**TITLE:** [PR-PC] Kings Forest Concept Plan Modification (Council Reference GT1/51 Department's Reference MP06/0318 MOD 7) and Kings Forest Project Application Modification (Council Reference DA11/0565.05 Departments Reference No. MP08/0194 MOD 5) to Accommodate the use of a Private Water Utility Licensed under the Water Industry Competition Act 2006 to Provide Water Supply and Sewerage Services including Recycled Water Reticulation to the Kings Forest Development No. 86 Melaleuca Road, Kings Forest

#### SUMMARY OF REPORT:

Council has received two requests from the NSW Department of Planning to review Modifications associated with both the Concept Plan and Project Applications for Kings Forest that would enable the use of a private water utility licensed under the Water Industry Competition (WIC) Act 2006 to provide water supply and sewerage services including recycled water reticulation to the Kings Forest Development.

Existing & Proposed Concept Plan (note grey 50m ecological buffer no longer showing up on the Concept Plan, purple dot proposed zone substation no longer showing up on the Concept Plan)

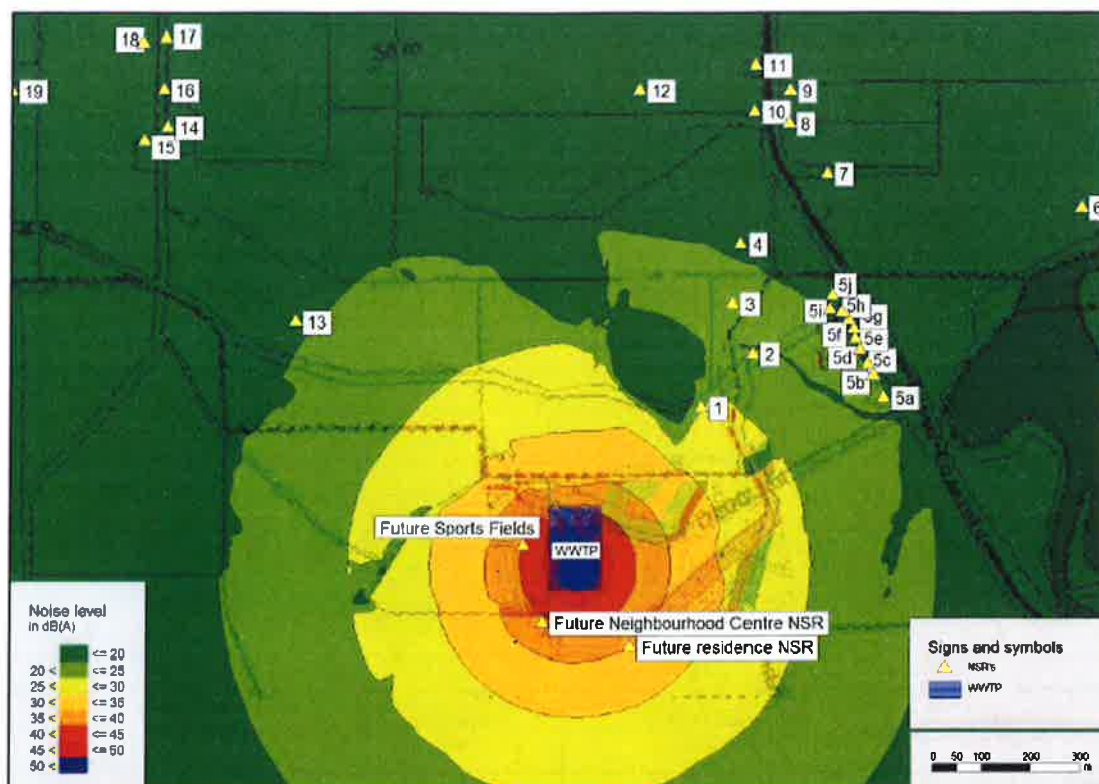
However, as can be seen from the below diagram the modification to the Concept Plan does more than just nominate the new SP2 site. The new plan removes other reference points such as the 50m ecology buffer (grey) and removes the nomination of the purple dot which represented the zone substation.

Before any new Concept Plan is endorsed it needs to be critically reviewed for any other inconsistencies

**Noise Map for Evening & Night Time Operational Phase**

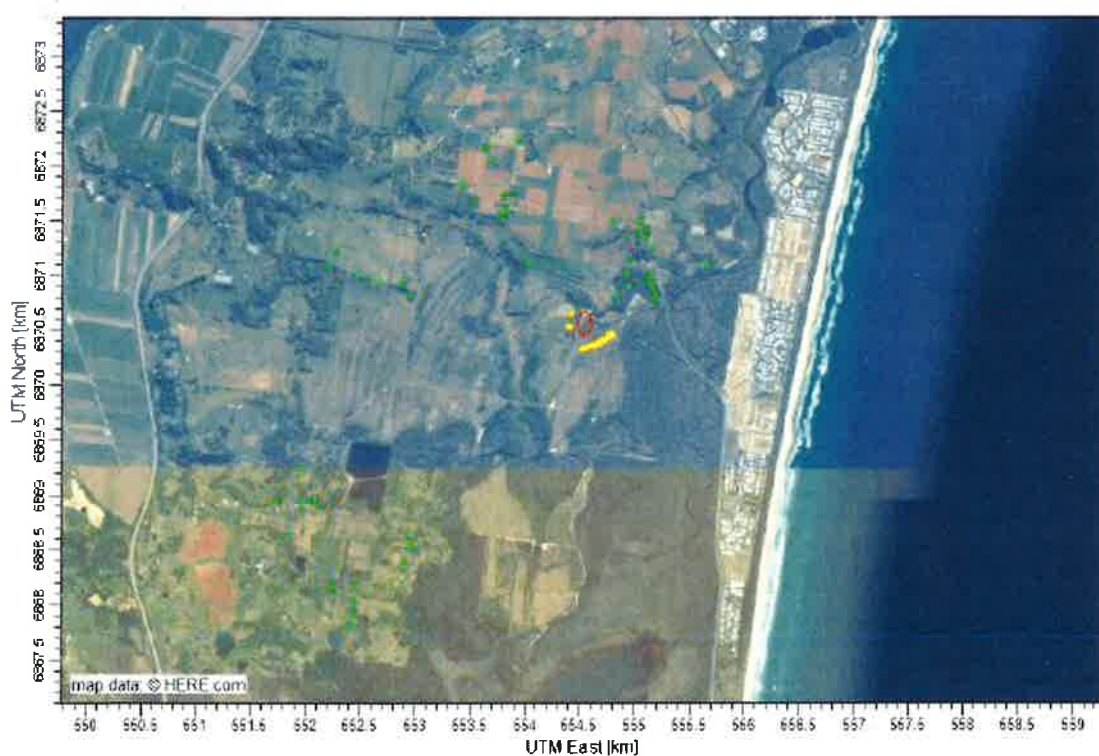
- Table 3-3: Project Specific Operational Noise Levels at NSR's identifies amenity criteria levels that do not appear consistent with NSW EPA's Industrial Noise Policy Table 2.2 Modification to acceptable noise level (ANL) to account for existing level of industrial noise. The background is relatively low in these areas and evening and night criteria for both locations would be lower than the project specific noise levels provided. It is noted however that based on Table 6-2 Operational Phase Predicted Noise Impact, criteria would still be met (based on their assumptions in the report).

- The consultant has advised that the majority of pumps are to be located within a building and the sound transmission loss of the building has been determined based on typical single panel Colorbond construction of 0.42mm thickness steel. This proponent has applied this to the noise model. It is unclear from the detail provided how this has been applied in modelling as there will be external pumps and possibly generators.

**Sensitive Receptor Locations and the WWTP Boundary (Green existing receptor locations and yellow future receptor locations modelled)**

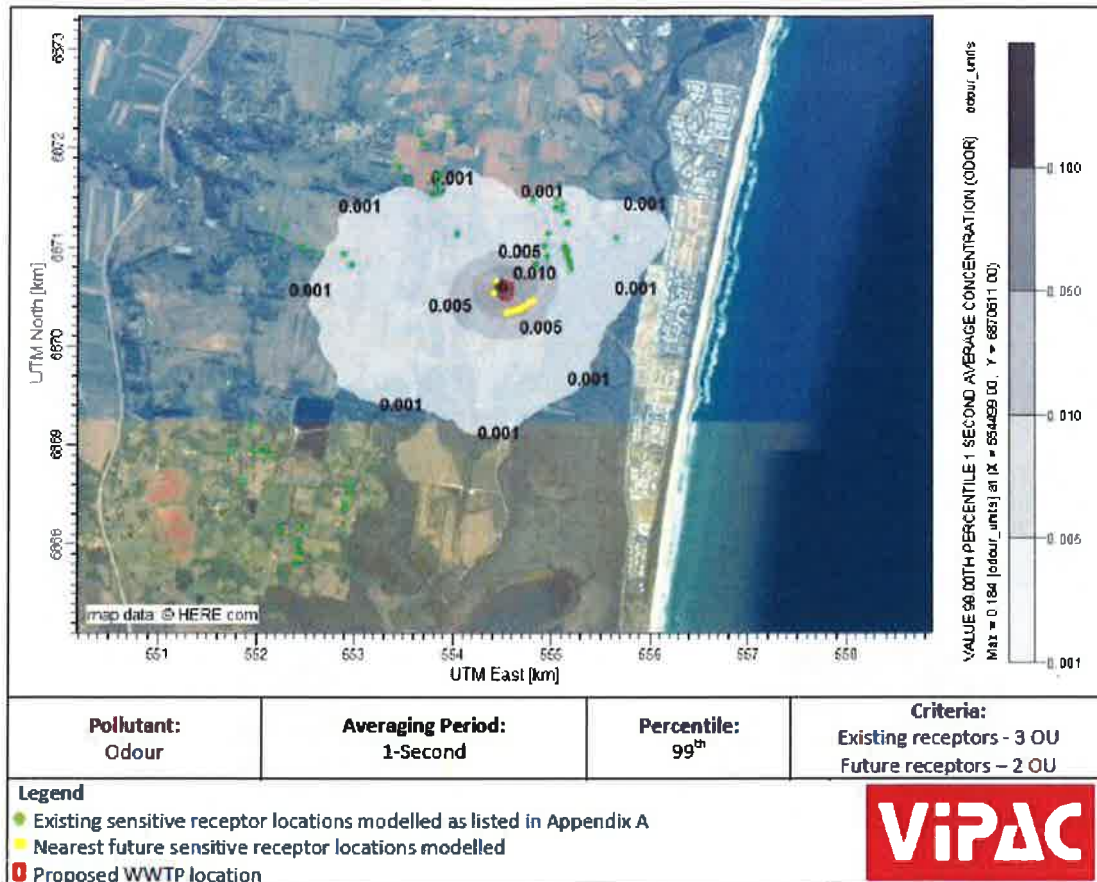
There is an apparent inconsistency between the plant site in the Noise and Odour studies and the area shown in Figure 1 of Attachment 1.

- Location of the WWTP appears to be closer to the existing receivers in Secret Lane (250m) as shown within the Odour Report compared to the Supporting Document by Planit.

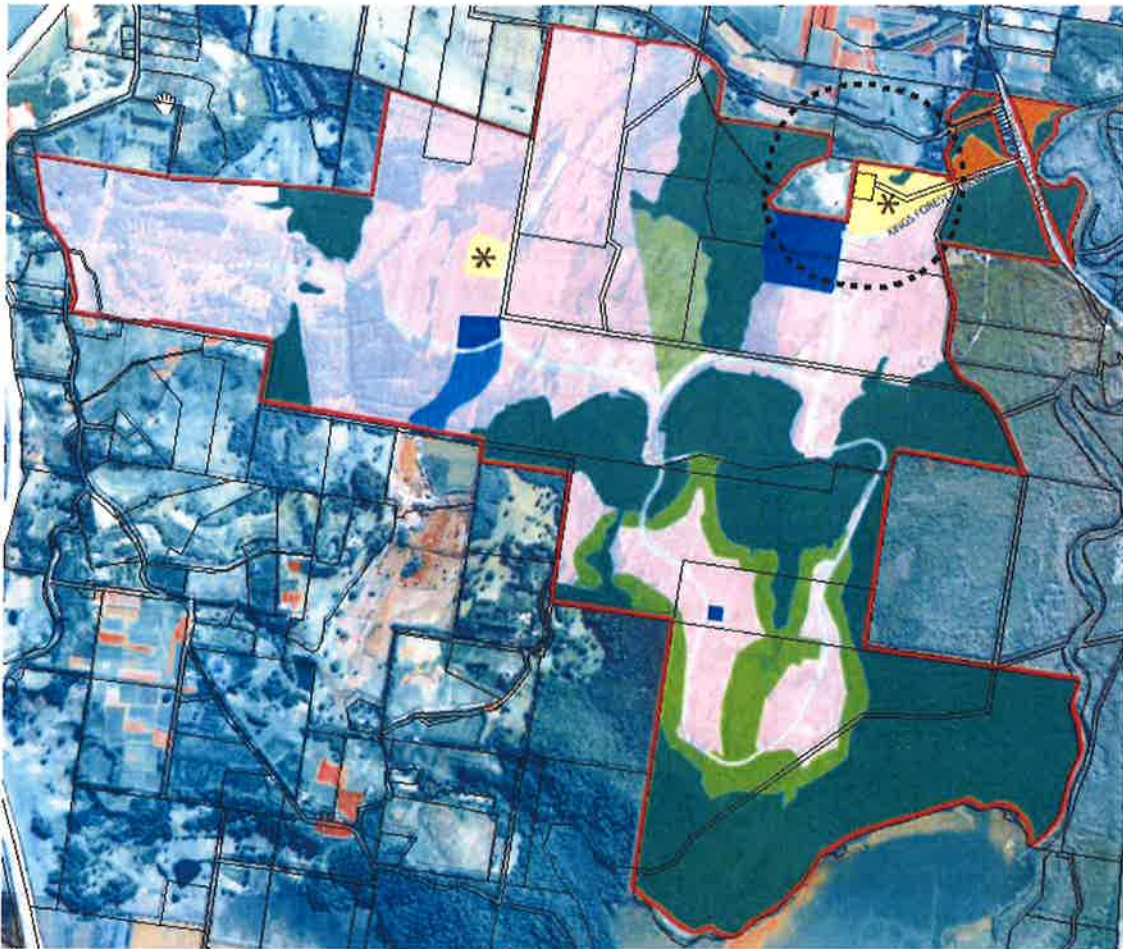
There is an inconsistency between the text and Figure 1 concerning the dimensions and area of the "landscape screen" and "vegetation screen" which are presumably the same thing by different names.

There is an apparent inconsistency between area shown on the Attachment 2 - Revised Concept Plan and Zoning Plan and the area shown in Figure 1 of Attachment 1.

The area shown in the revised Zoning Plan (Drawing Title: Land Zoning Map 2005 Amendments) apparently includes the current alignment of Depot Road which is the current access to the proposed Depot Road Sports Fields. The Odour and Noise Studies drawings indicate that the Water & Waste Water Treatment Plant will be constructed across part of the road reserve. Whether this is an issue will depend upon the timing of the provision of alternate access to the sports field site as part of the Kings Forest development.

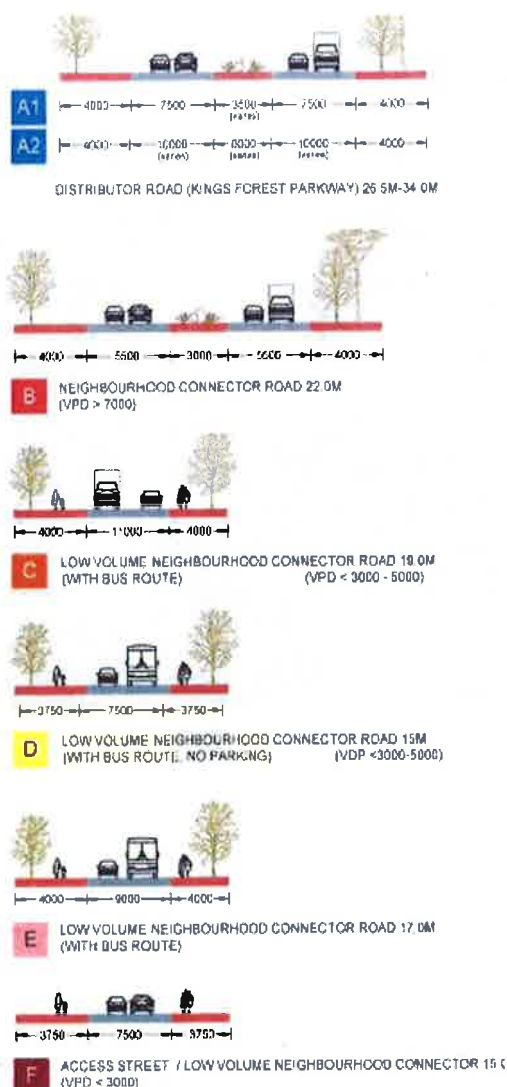
Having the "Town Centre" within the 200 – 400m portion of buffer would require special design and provision of air conditioning leading to potential additional cost for construction and operation of the Neighbourhood Centre.

Furthermore the Town Centre will have shop top housing which would be within the 200-400m portion which would be unacceptable.

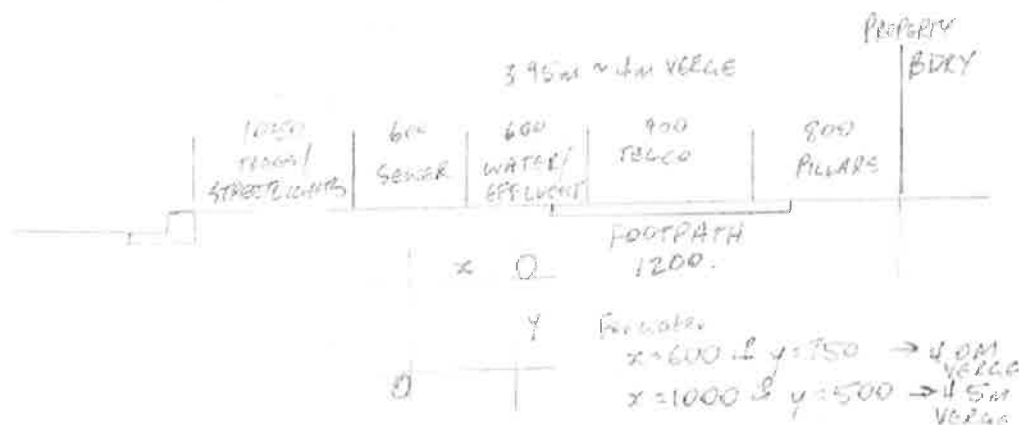
Subdivision approval is in place for the initial residential stages of Kings Forest, based on compliance with Council's Subdivision Manual and referenced specifications. Assuming that the proposed private water and waste water scheme will be similar in nature to that being currently discussed at Cobaki, it will provide for private water, sewerage and recycled effluent services (3<sup>rd</sup> pipe), to be located in the road reserve. As per the advice provided to the Department for Cobaki, the "3<sup>rd</sup> pipe" proposal cannot fit suitably within the minimum 3.75m wide road verge. If the private system is pursued, wider road reserves will mean modification of the subdivision DA

*It is considered that the minimum width for road verges depend on how well coordinated the other services are to minimise conflicts.*

*It would seem that under the three pipe proposal, there would be sewer on both sides of the road, water on one, and effluent on one. Wherever possible, effluent and water supply should be on opposite sides of the road to avoid potential cross connections / contamination, which also helps to minimise verge width.*

Figure 5.9.1: Typical services section

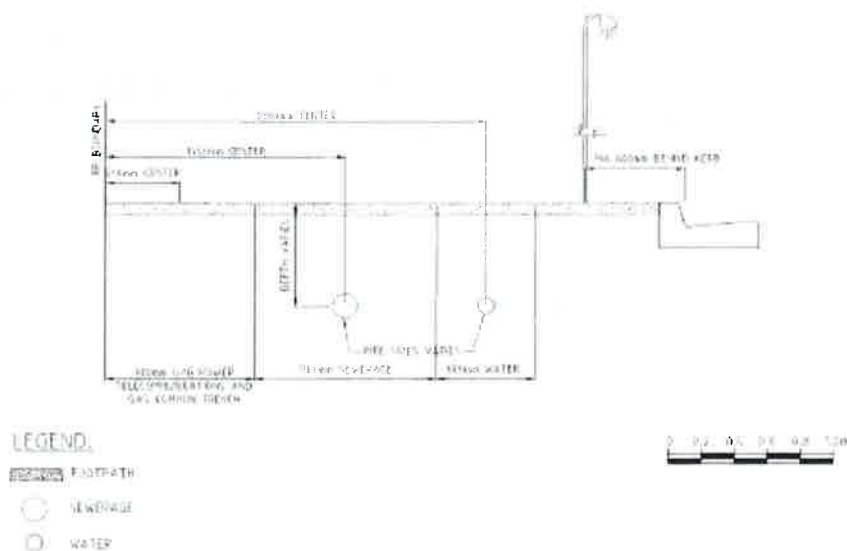
The deletion of the existing 5.9 is unacceptable as the above wording is an important inclusion within the Code as these sections ensure adequate protection of, and access to infrastructure whether they be Council or private assets.

Further, since Section 5.9 does not address the alignment of recycled water mains within road reserves, further modification of the section may be necessary and may result in the need for a wider road cross section. (See 5. *Service Allocation in Subdivision Design* earlier in report with the sketch proposing new cross section)
